ADDENDUM NO. 5

7/13/2021

TA-PM-2022-001

Philipse Manor Hall State Historic Site – Construction of Elevator/Restroom Addition, Interior and Exterior Rehabilitation and Site Enhancements

Sheet Title: Layout and Materials Plan
Drawing Number: L300
Bid Documents
Project Number: 18006.47
Sheet:

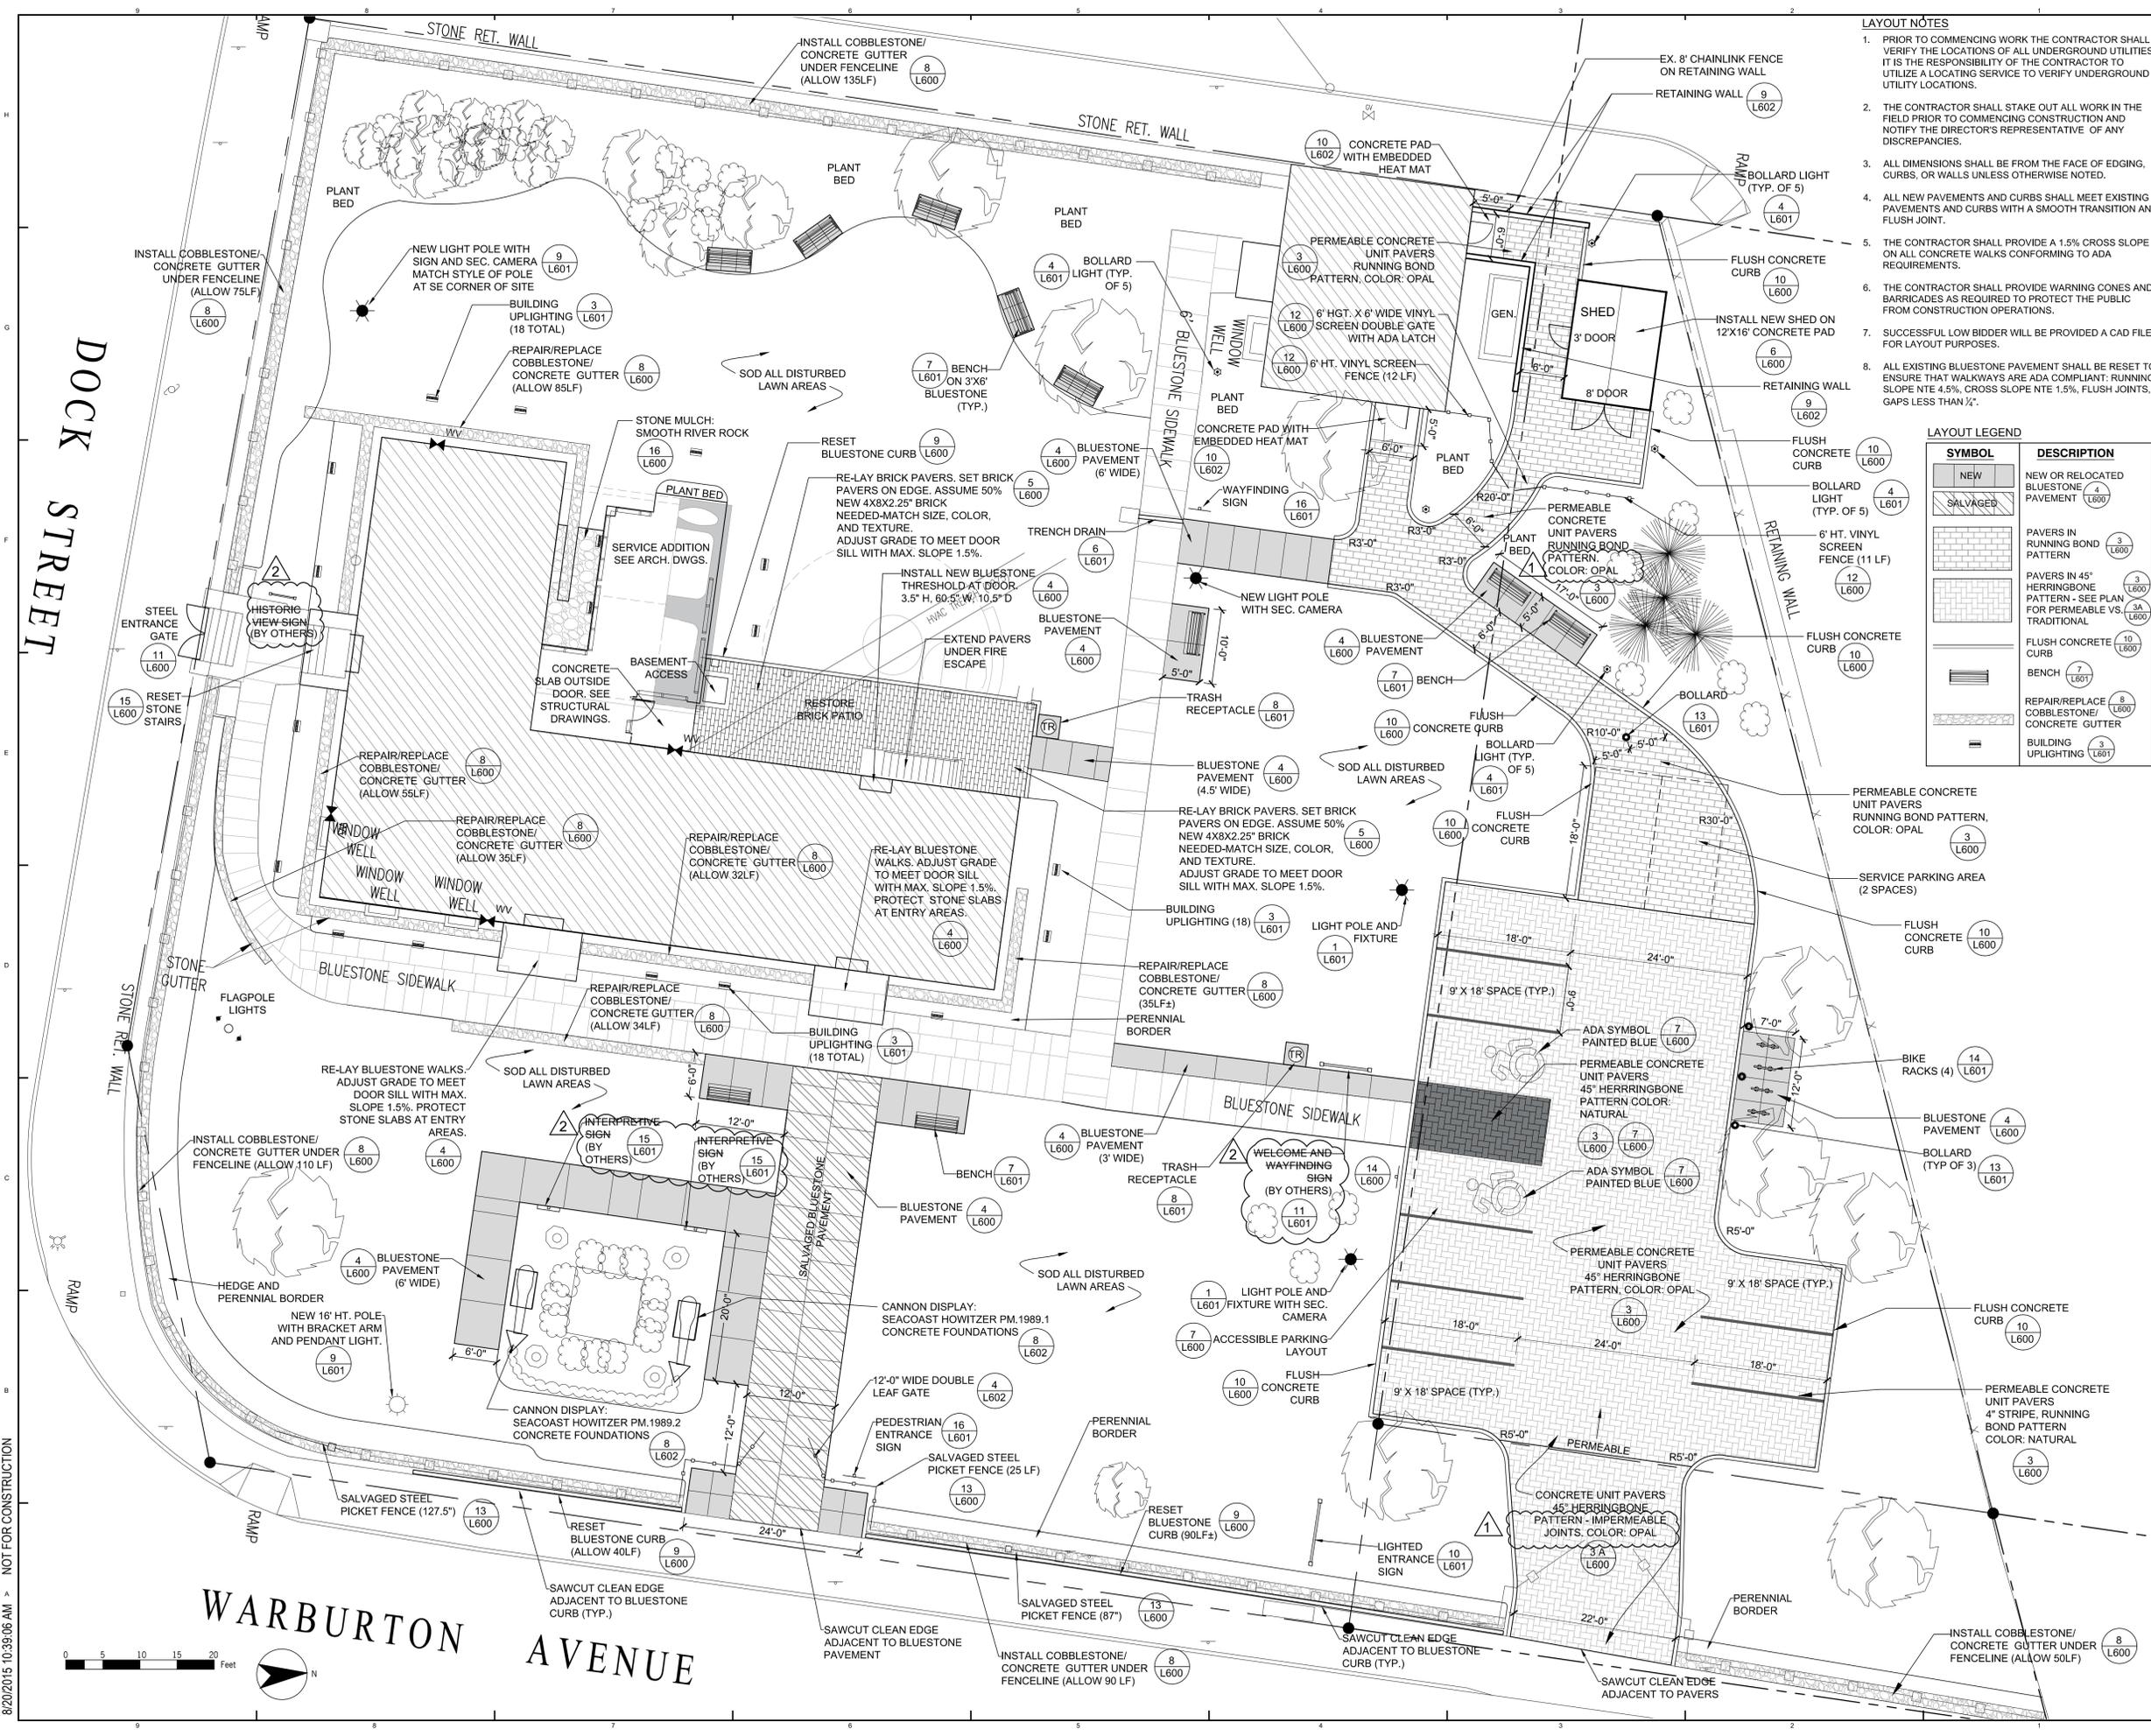
Q5. Please provide sections/details/specs for the 12' x 16' storage shed shown on L300.

- a. **Response: The design intent is this is a prefabricated storage shed. Refer to specification section 13 34 41 - Wood Portable Buildings.**

Sheet Title: Site Details
Drawing Number: L601

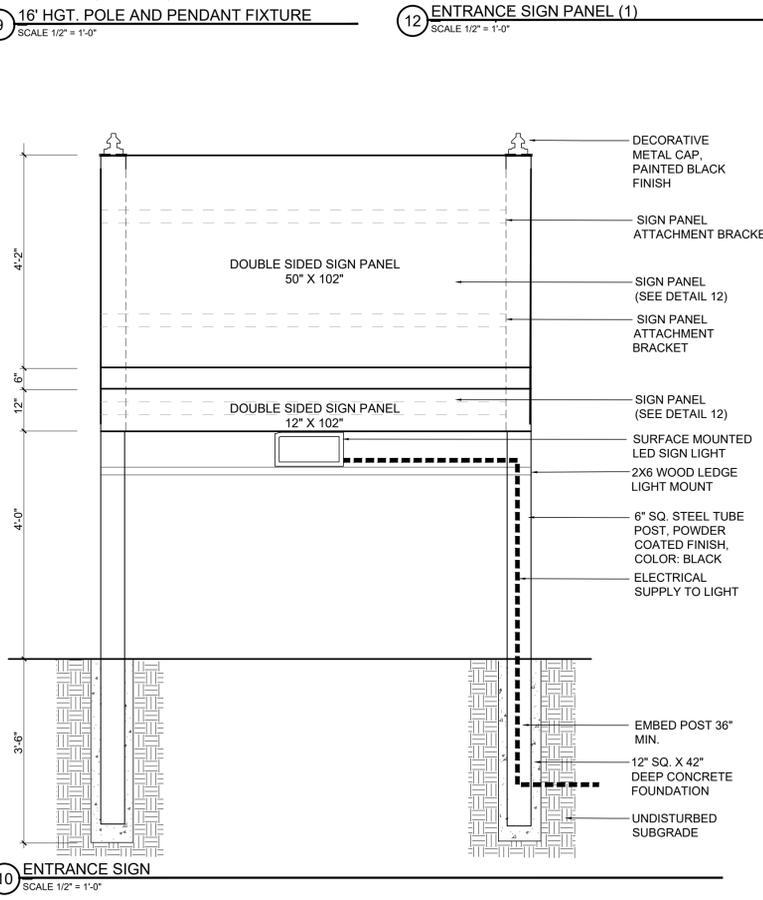
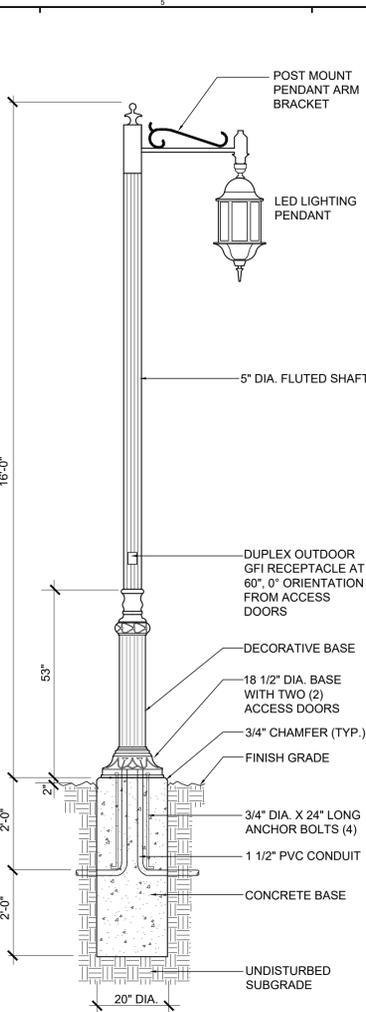
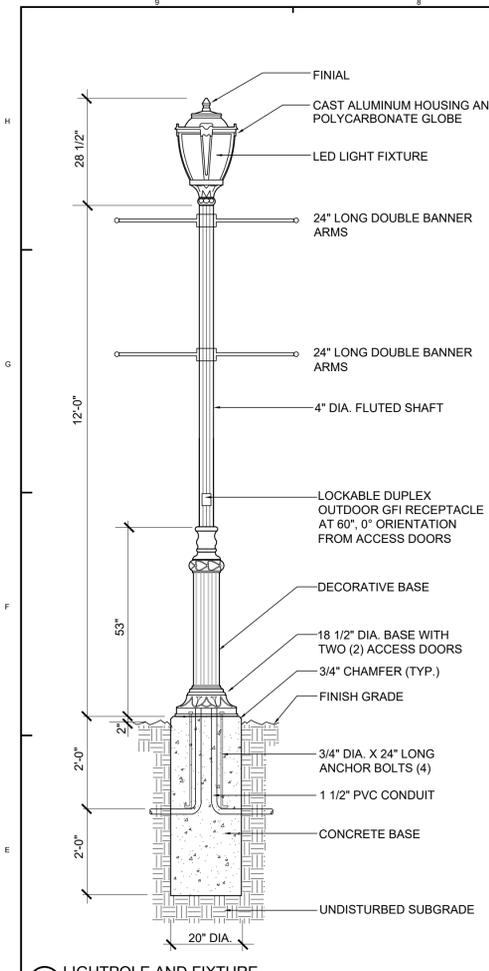
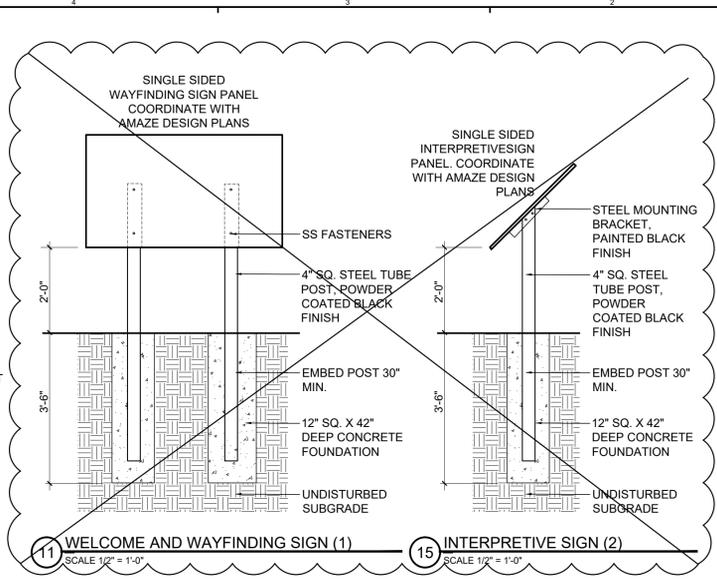
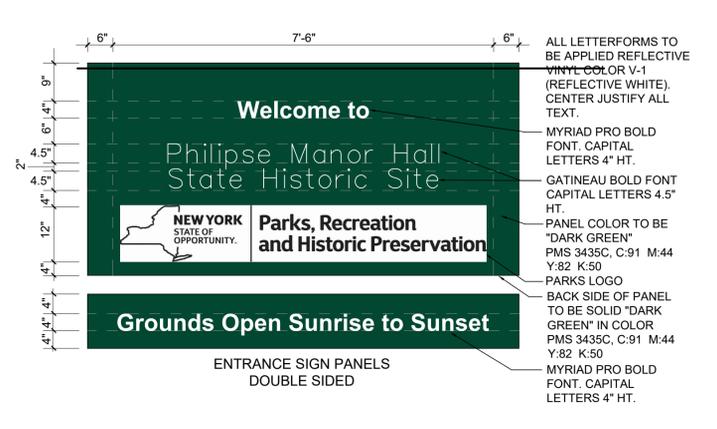
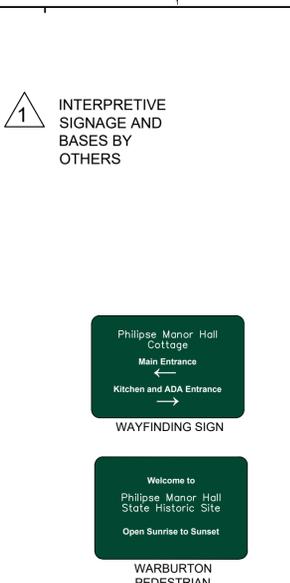
Q37. *Please provide sections/details/wall thickness of the tube steel supports at the entry sign shown in detail 10/L601.*

Q38. *Please provide the substrate material for the double-sided entrance sign (12/L601).*

a. Tube steel supports shall be 6" x 6" x .375" wall square tube in accordance with ASTM A500.

a. 6MM double-sided aluminum composite sign panel with polyethylene core. Sign panel mounted to posts with aluminum angle irons (front and back).
